Watfore Limited
**Creamfields Residential
Development**
**Traffic and Transportation
Assessment and Mobility
Management Plan Statement**

252666-00-RPT-TTAMMP-SHD

Issue 4 | 18 February 2022

Road Safety Audit Stage 1

2.1 Problem: End Parking Bays

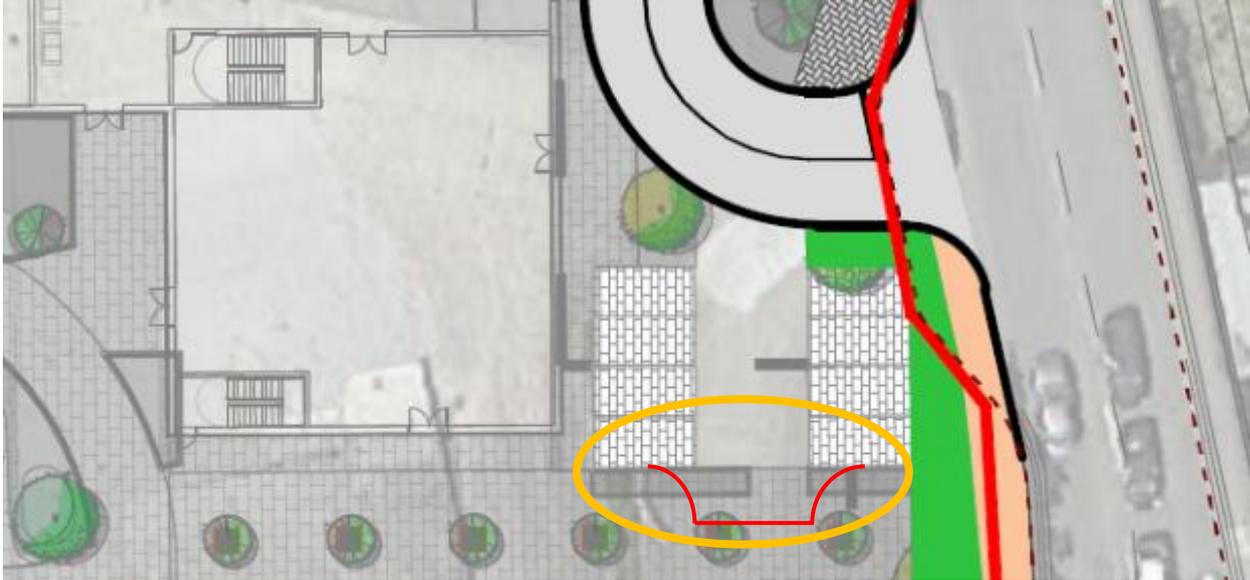
It may be difficult for motorists to use some of the end parking bays when all adjacent spaces are occupied resulting in increased reversing movements to enter or exit these spaces. This would increase the risk of a collision with another vehicle or a pedestrian.

A swept path analysis should be carried out to ensure all spaces are accessible. A small turning area should also be provided such as extending the end of the road a little more to the south as shown above.

2.2 Problem: Pedestrian Facilities (Northern Proposed Access)

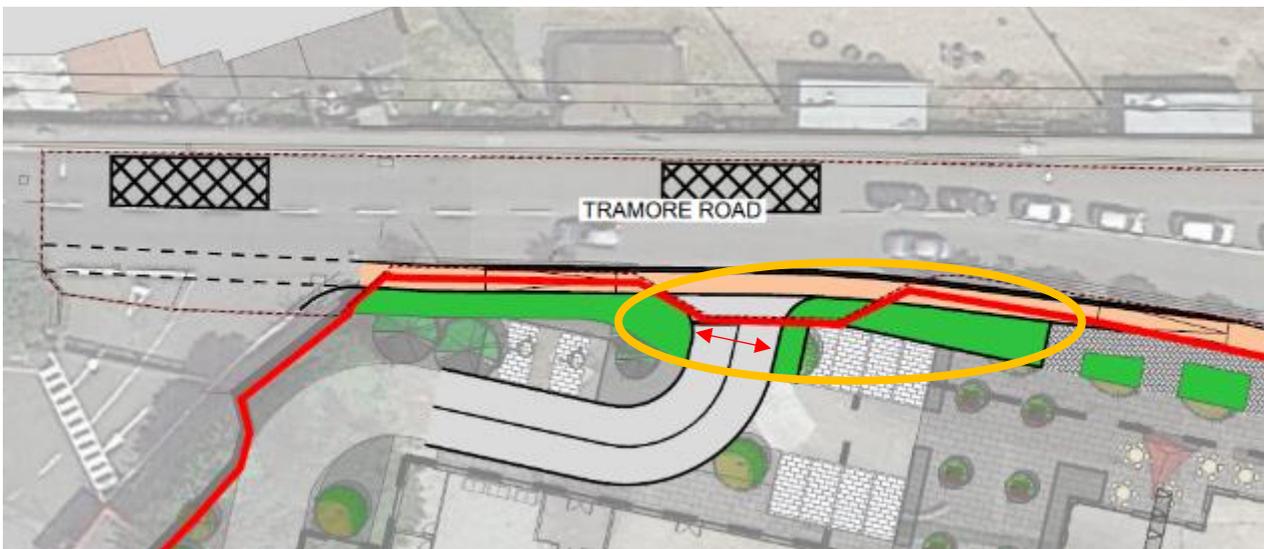
There are no safe means for a pedestrian to cross the proposed northern access. Currently there is poor provision for pedestrians along the southern side of Tramore Road resulting in pedestrians walking on the carriageway with increased risk of being stuck by a vehicle.

A public footpath should be provided along the entire site frontage along Tramore Road. Ensure that this footpath safely terminates with an uncontrolled crossing either at the access to Musgraves northern entrance or across Tramore Road to the existing footpath on the opposite side of Tramore Road.

2.3 Problem: End of Cycle Track (Northern Musgrave Access)

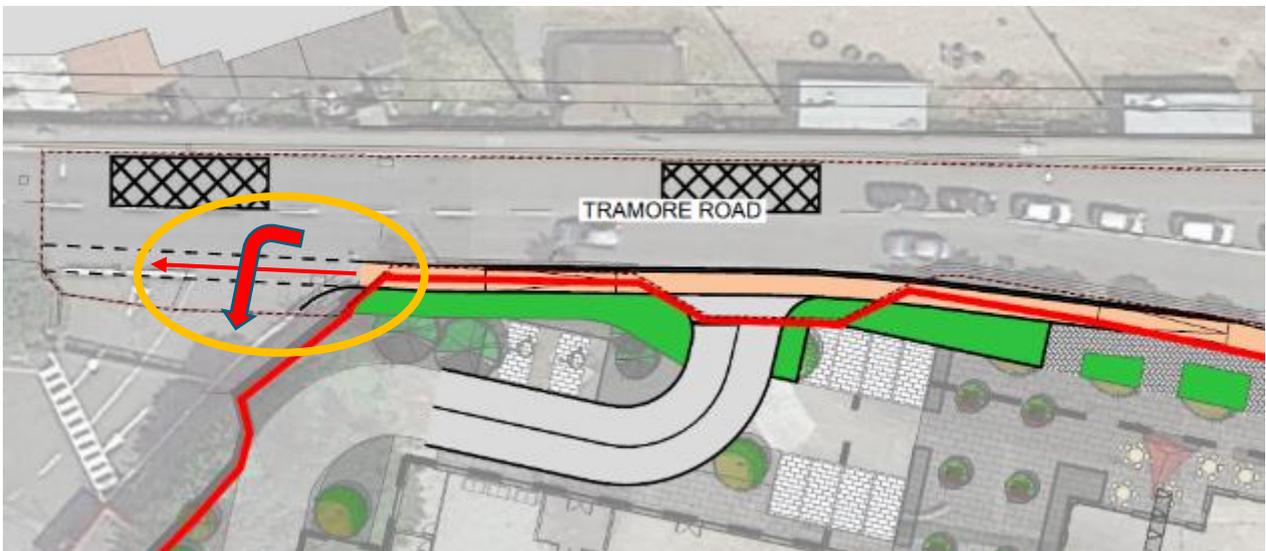
It is proposed to end the cycle track abruptly at the northern Musgrave access. Cyclists are required to exit the cycle track at a location where vehicles turn left into the proposed development increasing the risk of a collision between a cyclist and a left turning vehicle.

A red colour surface of the cycle track should extend across the Musgrave Access.

2.4 Problem: Large Shared Surface Area

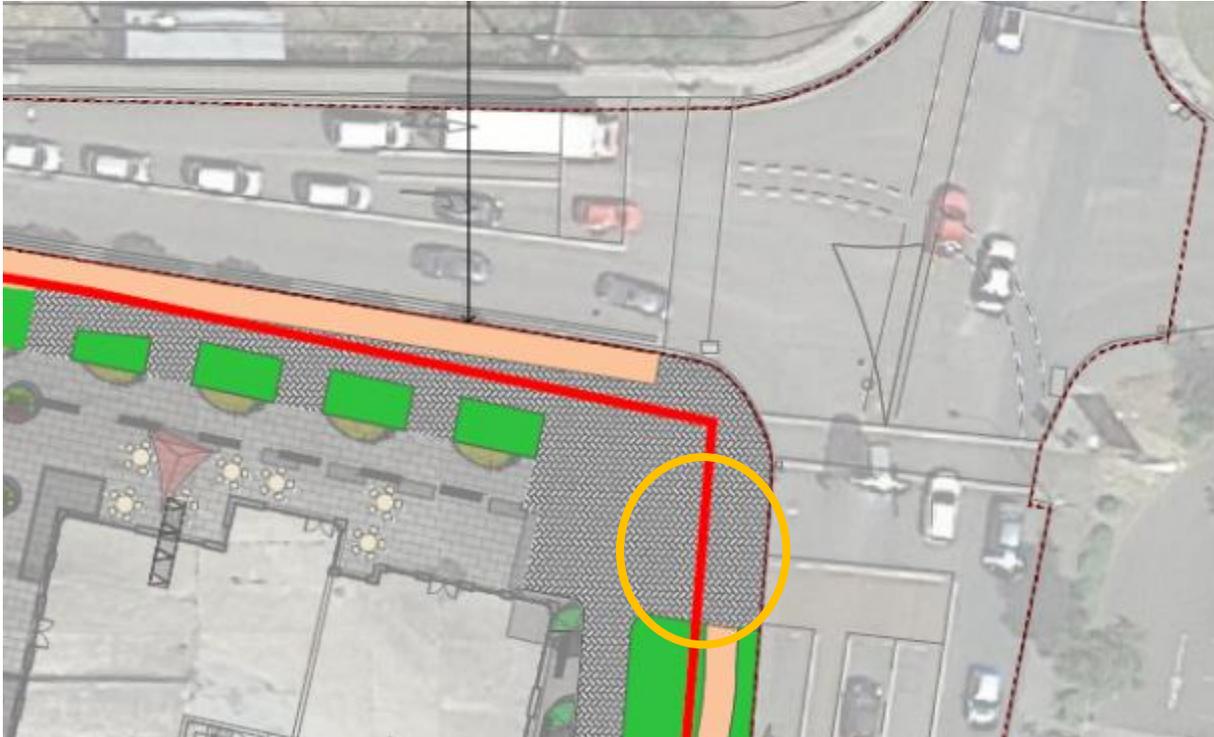
It is proposed to make a large area of footpath as a shared surface where cyclists are permitted to mix with pedestrians increasing the risk of a collision between cyclists and pedestrians.

2.5 Problem: Long Pedestrian/Cycle Crossing (Musgrave Entrance)

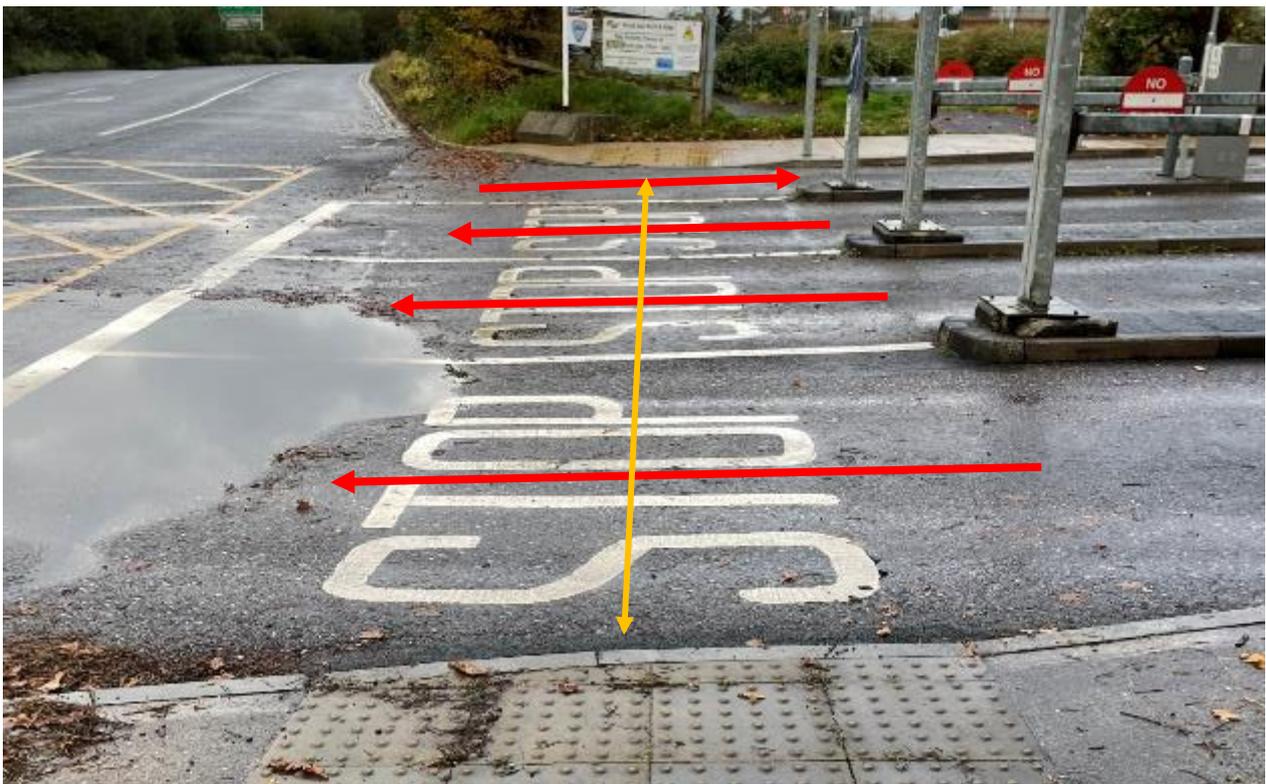
The uncontrolled crossing across the existing Musgrave entrance and Centra exit on Kinsale Road is very long and offers little protection for pedestrians/cyclists trying to cross especially pedestrians with a mobility impairment. As well as a very wide access road, the corner radii are very large to accommodate articulated lorries accessing the facility This increases the time a pedestrian/cyclist is exposed to general traffic increasing the risk of getting struck by a turning/exiting vehicle.

Appropriate measures should be implemented to reduce the crossing distance prior to the development becoming operational. Appropriate measure could include narrowing the access width at the crossing and reduce the corner radii if possible.

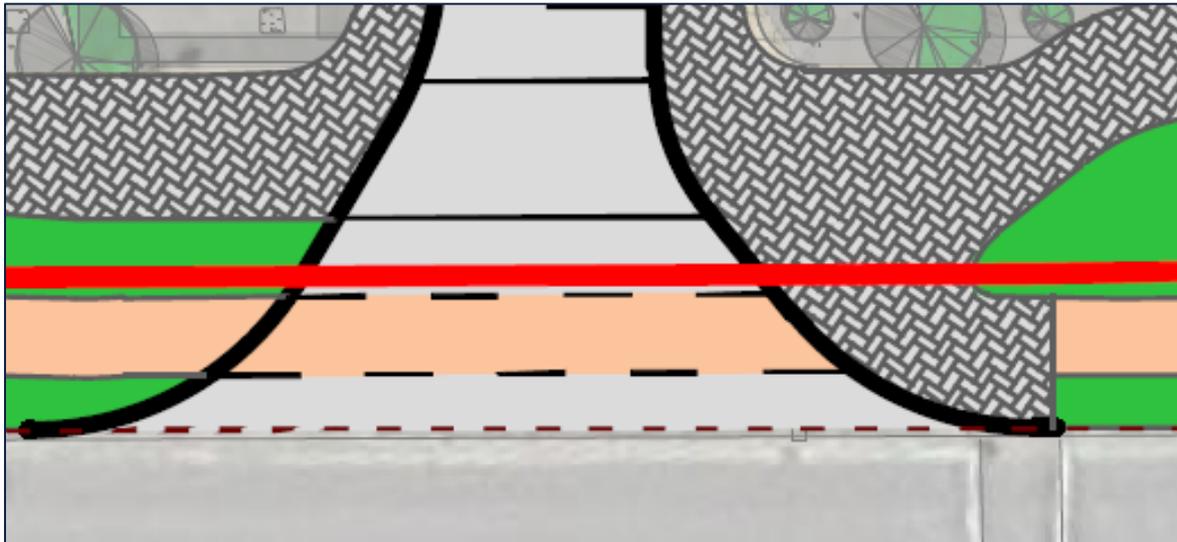
There is no pedestrian push-button control located in the central pedestrian refuge island to cater for a pedestrian with a mobility impairment who might not have sufficient time to cross this long crossing during

one green pedestrian stage of the traffic signals. This increases the risk of a vulnerable road user trying to cross the remaining of the carriage during the red signal stage and getting struck by a vehicle.

An additional pedestrian push-button should be installed to call a pedestrian phase when a pedestrian is waiting on the pedestrian crossing.

2.12 Problem: Merging Cyclists and Left Turning Traffic

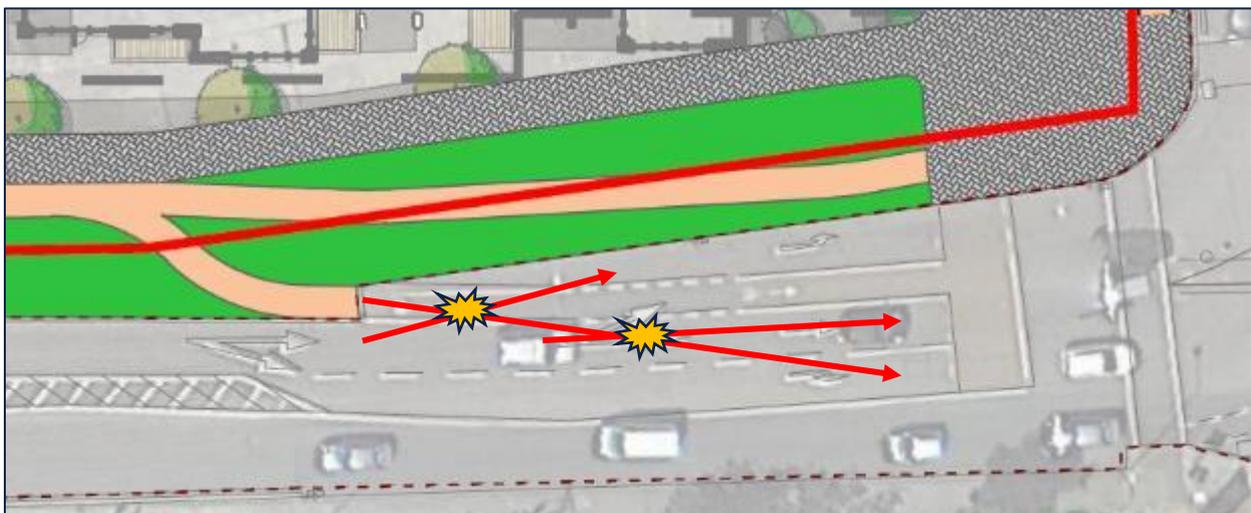
The proposed link from the cycle track to the carriageway on Kinsale Road creates a significant risk for cyclists due to left turning vehicles crossing the cycle track at this point. During the site visit, vehicles were observed crossing the cycle lane where it merges with the carriageway. Given that cyclists and motorists are travelling in the same direction, there is poor intervisibility between users at this point, increasing the risk of a side swipe type collision. When traffic is moving at the junction, it is difficult for cyclists to turn right into Turners Cross Retail Park as they would need to cross a lane of straight-ahead traffic to use the right turn lane.
